PRATT & WHITNEY CANADA  
**SERVICE BULLETIN**

P&WC S.B. No. 41055

TURBOSHAFT ENGINE  
ACCESSORY GEARBOX DIAPHRAGM - REPLACEMENT/MODIFICATION OF

**PT6C-72-41055**  
Cover Sheet

Accessory Gearbox Diaphragm - Modification of  
Figure 1 (Sheet 1 of 2)

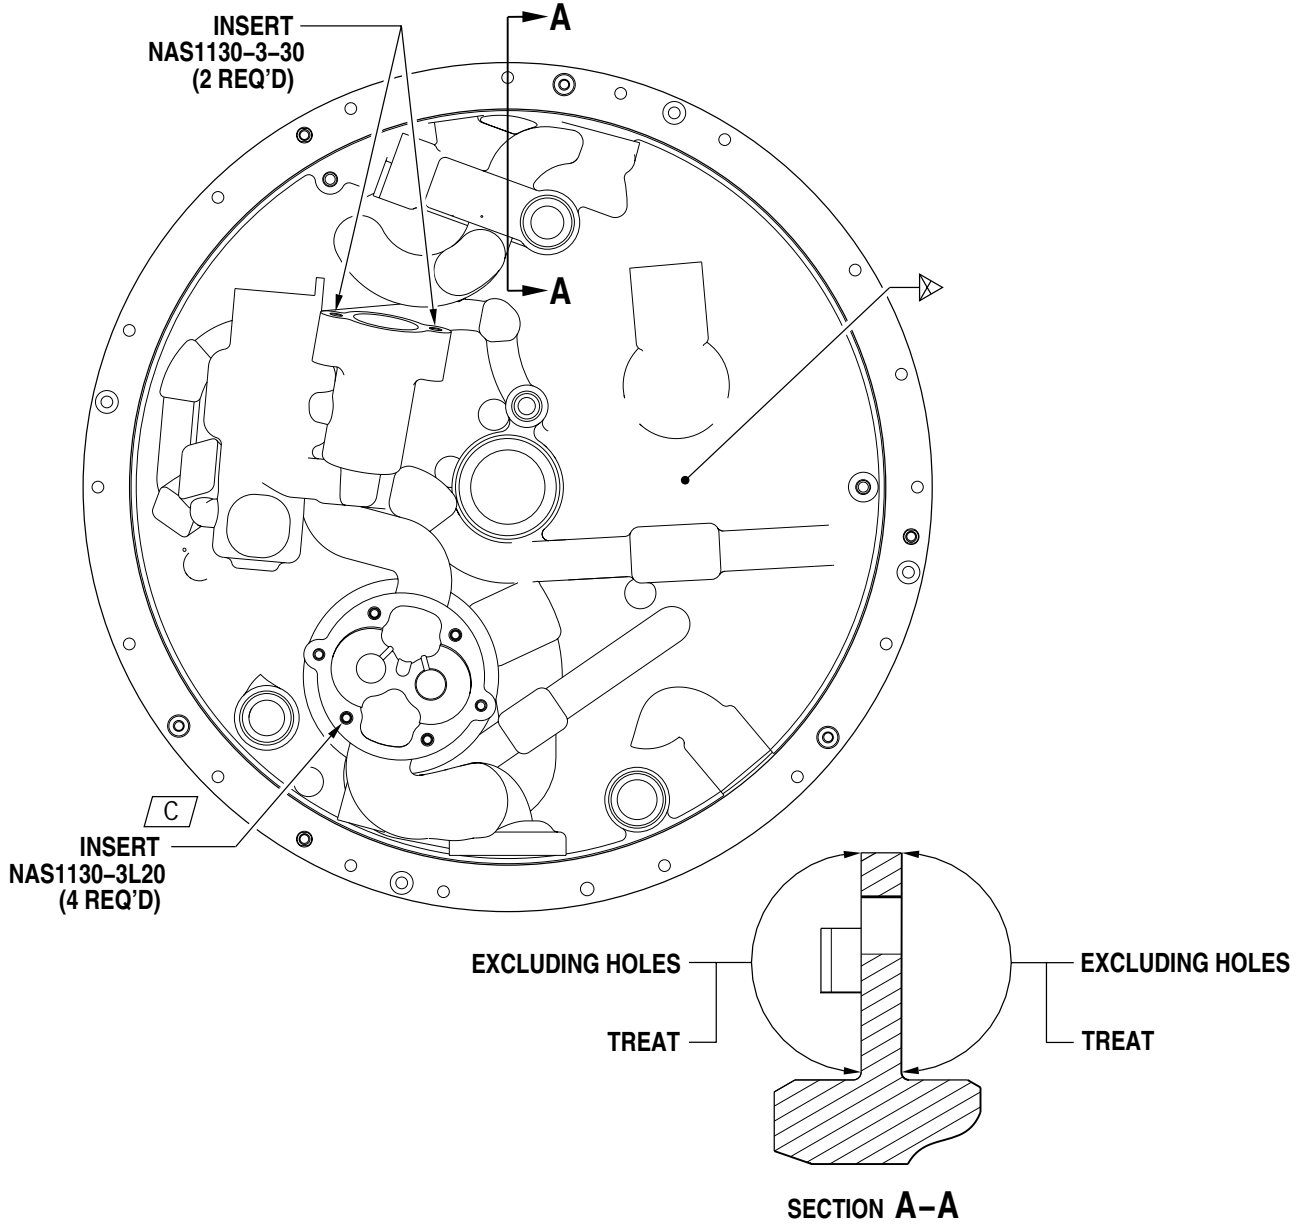
B. Modify the existing accessory gearbox diaphragm assembly as follows (Ref. Figure 1):

- (1) Mask areas adjacent to section A-A on diaphragm assembly.
- (2) Remove existing coating in accordance with SPOP19 (Ref. overhaul manual).
- (3) Pressure flush in accordance with overhaul manual.
- (4) Apply AMS2474 in accordance with SPOP 42 at area shown (Ref. Section A-A).
- (5) Touch up any other bare spots on diaphragm assembly in accordance with SPOP 42 (Ref. SPM, Chapter 70-44-01).
- (6) Remove masking from accessory gearbox diaphragm assembly.
- (7) Install inserts listed under new P/N in Para. 2.C., Material Information, in accordance with the overhaul manual instructions (Ref. OHM 72-00-00, ENGINE - REPAIR).

Accessory Gearbox Diaphragm - Part Progression  
Figure 2

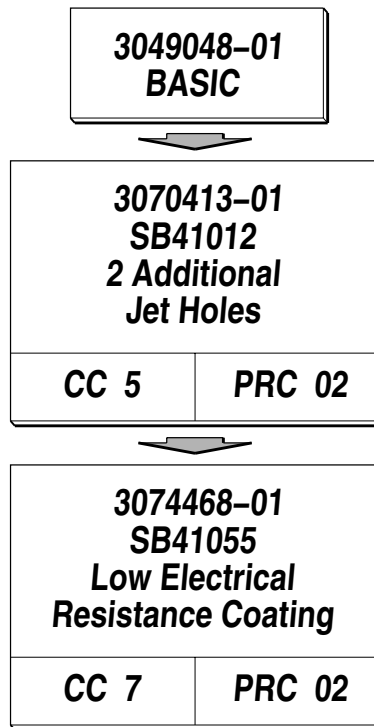
A. Refer to Figure 2 for the accessory gearbox diaphragm part progression.
